| 10/695,295 | 10/28/2003 | Joseph A. Gonzales | A-2966-AU | 4188 |

Office Action Summary

DETAILED ACTION

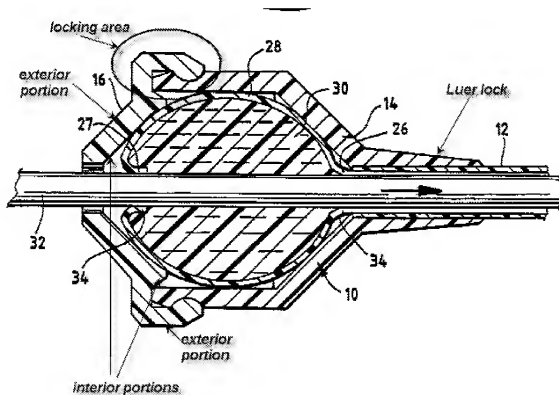
Weinstein discloses, see Fig. below, a housing including a proximal housing portion and a distal portion 14 to define a gel cavity 30. a seal material disposed in the gel cavity, the seal member including a gel having non-compressible characteristics; a proximal guide tube 16 extending axially proximally from the proximal housing portion; the proximal guide tube facilitating insertion of a surgical instrument into the seal material; a distal guide tube (closes to Luer lock arrow) extending axially distally from the distal housing portion, the distal guide facilitating retrograde insertion of the surgical instrument into the surgical seal; wherein the proximal guide tube includes exterior portions extending proximally of the proximal housing portion and interior portions extending distally of the proximal housing portion. Weinstein

discloses a luer lock (see Fig. below) coupled to the distal guide tube 14 or 12, the distal guide tube being included within the luer lock.

Regarding claim 6, Weinstein further discloses a node 27. Because Applicant does not clearly explain the purpose or function of node in the device, nor show the node clearly in Figs. 6-7. Therefore, Examiner interprets the element 27 as a node.

Regarding claim 10, Weinstein discloses a first housing portion 16, a second housing portion 14; a gel 30 disposed within the gel cavity and having properties including flowability and incompressibility, the gel having characteristics for creating a pressure on the instrument to form a seal with the instrument, and means for moving the second housing portion relative to the first housing portion to increase the pressure of the incompressible gel on the instrument and create a locking force tending to inhibit movement of the instrument relative to the valve (see Fig. below, or col. 1, line 47)

In response, Examiner clearly point out in Fig. 3 above.

In response, Because Applicant does not clearly explain the purpose or function of node in the device, nor show the node clearly in Figs. 6-7. Therefore, Examiner interprets as broadly that the element 27 as a node. Furthermore, Fig. 3 clearly shows that the sealing material having axially channel when instrument facilitate placing an axial channel.

In response, device of Weinstein clearly shows in Fig. 3 that the first and second housing portion 14, 16 engaged to each other and one skill in the art would recognize that it will produce or increase the pressures of the gel on the instrument and there a locking force to engage the first and second portion together to inhibit movement of the instrument relative to the valve (see Fig. above)

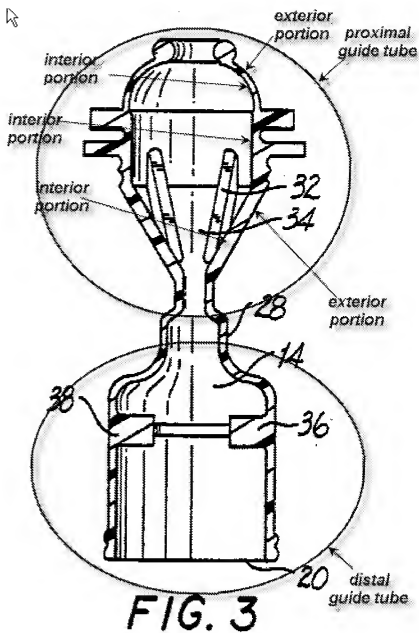
Gravenor discloses a surgical valve having an axis extending between a proximal and a distal end comprising:

a housing including a proximal housing portion 26 and a distal portion 18 to define a gel cavity 42. a seal material disposed in the gel cavity, the seal member including a gel having non-compressible characteristics; a proximal guide tube 16, 22, 26, 28 extending axially proximally from the proximal housing portion; the proximal guide tube facilitating insertion of a surgical instrument into the seal material; a distal guide tube 18, 20 extending axially distally from the distal housing portion, the distal guide facilitating retrograde insertion of the surgical instrument into the surgical seal; wherein the proximal guide tube includes exterior portions extending proximally of the proximal housing portion and interior portions extending distally of the proximal housing portion.

Regarding claims 4-5, the seal material defines 42 defines an axial channel through the gel, and the proximal guide tube contacts the seal material around the axial channel at the proximal end of the valve, see Fig. 7; the seal material and the first housing portion form a subassembly free of a circumferential seal between the seal material and the first housing portion; and subassembly to form a circumferential seal between the gel and the first housing portion; the proximal guide tube applies a force to seal material in subassembly to form a circumferential seal between the gel and the first housing portion, see Fig. 7.

Regarding claims 6-9, Gravenor discloses that a first housing portion defining a gel cavity; a node 32 (Fig. 3) or 46 (Figs. 10, 14-16) an axial channel; a subassembly including the seal material disposed in the gel cavity; a second housing portion disposed juxtaposition to the first housing portion and applying a force to the seal material in the subassembly, the force being of a magnitude sufficient to place the channel of the seal material in a closed state (Figs. 8-9); wherein the guide tube (proximal guide tube) contacts the node 32 or 46 of the seal material to apply the force to seal material (Figs. 8-16).

In response, according to www.answers.com define the tube: as a hollow cylinder, especially one that conveys a fluid or function as a passage. Device of Garvener including a hollow cylinder and able to convey a fluid or function as a passage also. See Fig above.

In response, please see Fig. above.

In response, Applicant does not clearly disclose the node or function of the node. Furthermore, Applicant does not show clearly the node in Figs. 6-7, therefore, Examiner interprets broadly that the node is as protuberance, swelling, a knob, or a knob. Therefore, element 32 or 46 can be read as a node.

Gravener clearly discloses that the seal material having an axial channel (Figs. 6-16).
